Product Change Notice

Issue Date: 26-May-2021

New dice replacement for Surface Mount Display

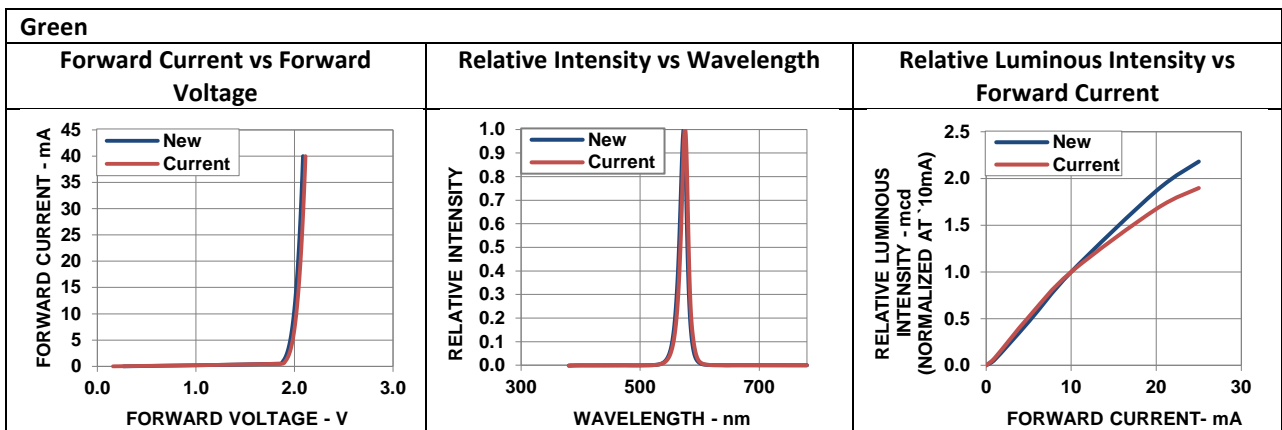
Following are changes in product characteristic:

1. Forward Voltage vs Forward Current
2. Relative Intensity vs Wavelength
3. Relative Intensity vs Forward Current

Part	Current (bottom view)	New (bottom view)
HDSM-281C		
HDSM-283C		
HDSM-291C		
HDSM-293C

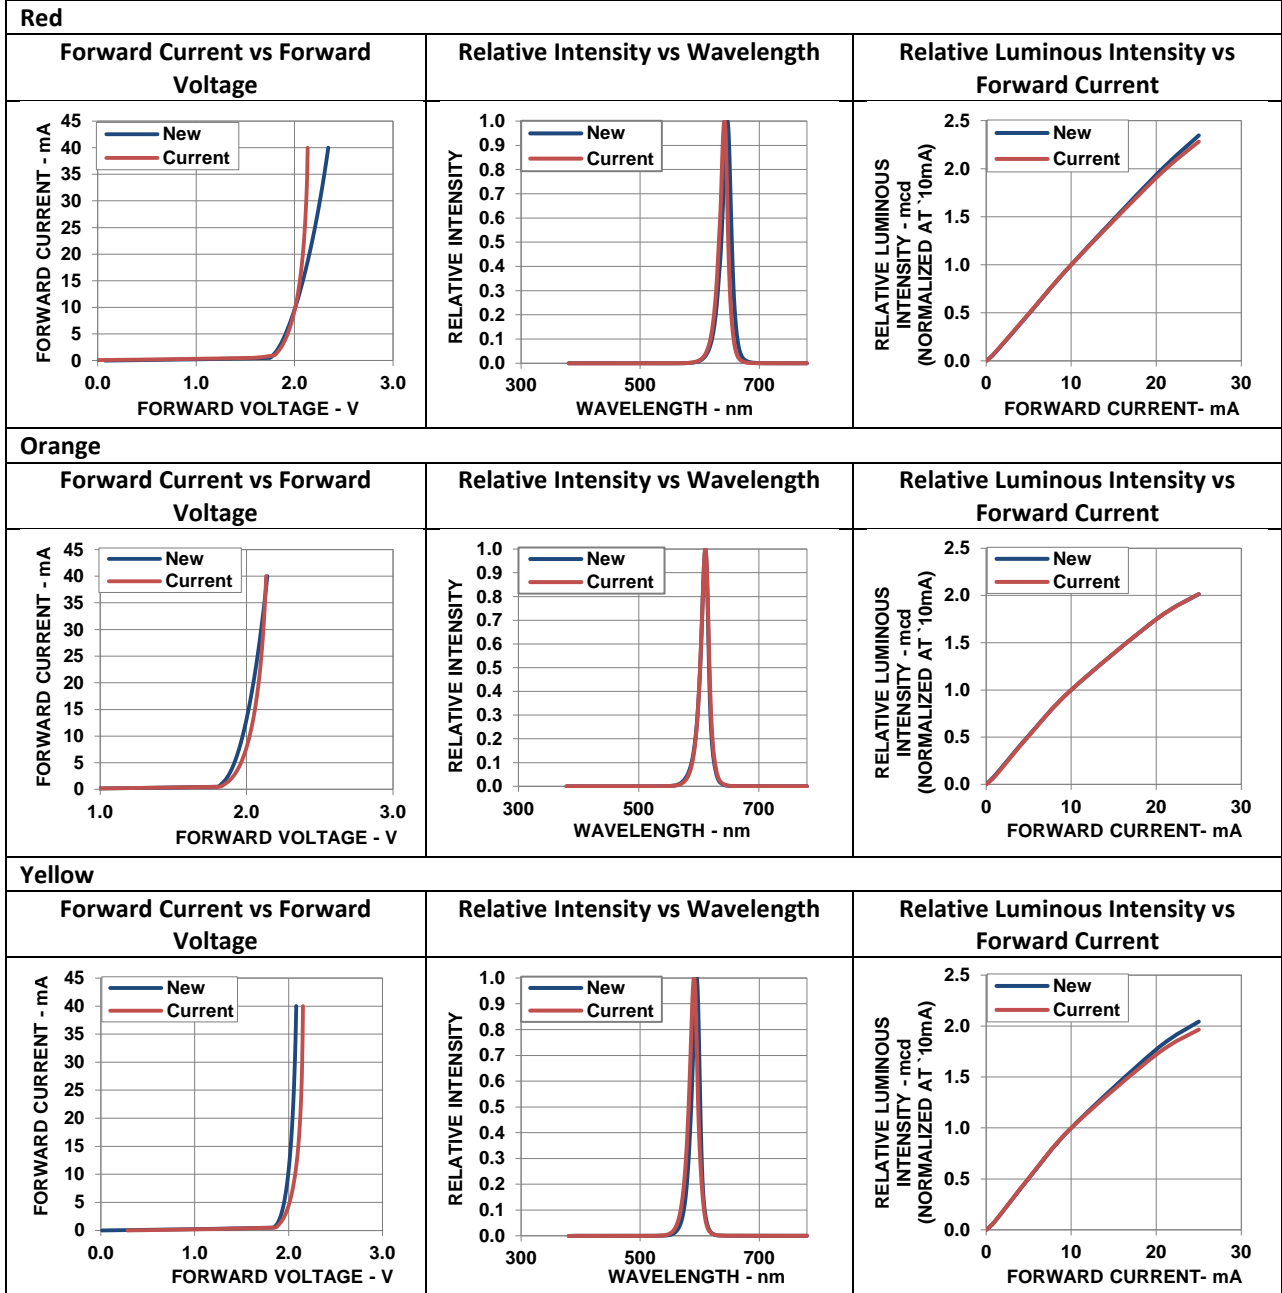
For HDSM-28xC & HDSM-29xC, there is PCB layout change as illustrated below:
